Job Name: Land at Wandleys Lane (Application WA/73/17/OUT)
Job No: 38848-5501
Date: 10th January 2018
Prepared by: Gary Heard
Subject: **A27 Linsig modelling**

1. The following note has been prepared to address Highways England (HE) officer comments in relation to the planning application WA/73/17/OUT as set out in their emails of 18/12/2017 and 21/12/2017.

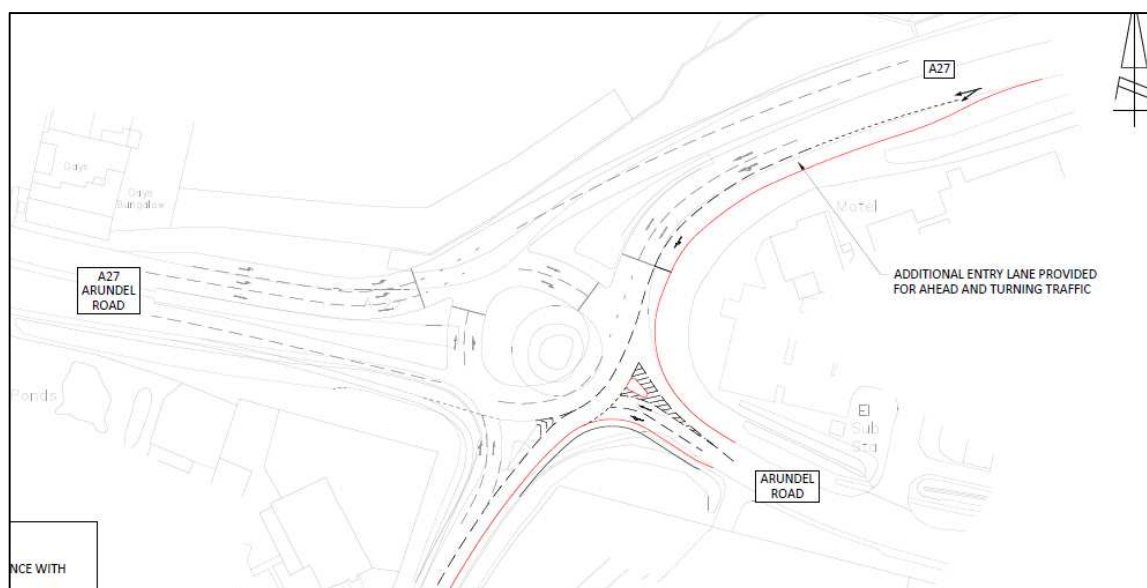
12. The Local Plan mitigation scheme for the west roundabout is illustrated below. It comprises partial signal control and kerb widening / realignment.

14. It is noted that the AM and PM models demonstrate negative PRC values with -3.4% and -27.4% respectively.

16. It is noted that the AM and PM models demonstrate negative PRC values with -7.9% and -31.7% respectively. This compares to -3.4% and -27.4% (respectively) without Wandleys Lane.
17. Hence it is demonstrated that the Wandleys Lane development has a negative effect at this junction on the basis of the modelling described above.
18. A mitigation scheme has been considered that increases the saturation flow of the A27 east arm by 100 PCUs per hour per lane. This is equivalent to a widening of 0.7m at the stop line for each lane – a total increase in entry arm width of 1.4m.
19. The above model has been re-run after increasing the A27 east arm saturation flow. The model output (optimised for lowest PRC) is attached and summarised below.

20. It is demonstrated that the proposed mitigation results in at least a nil detriment solution with respect to PRC and on this basis offsets the effect of the Wandleys Lane development.

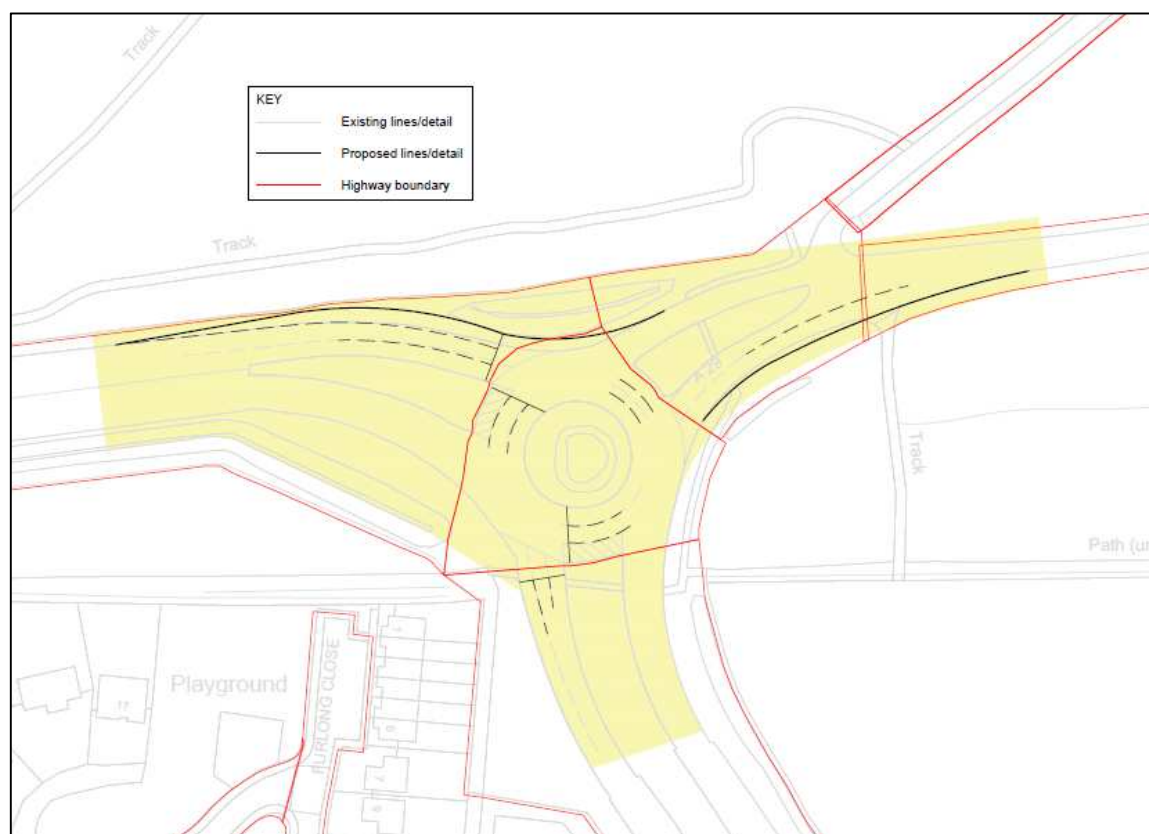
35. The Local Plan mitigation scheme for the east roundabout is illustrated below. It comprises partial signal control and kerb widening / realignment.

37. It is noted that the AM and PM models demonstrate positive PRC values with 8.3% and 10.6% respectively.

39. It is noted that the AM and PM models demonstrate positive PRC values with 5.8% and 8.5% respectively.
40. On this basis no mitigation is required to offset the effects of the Wandleys Lane site traffic within the Local Plan scenario.
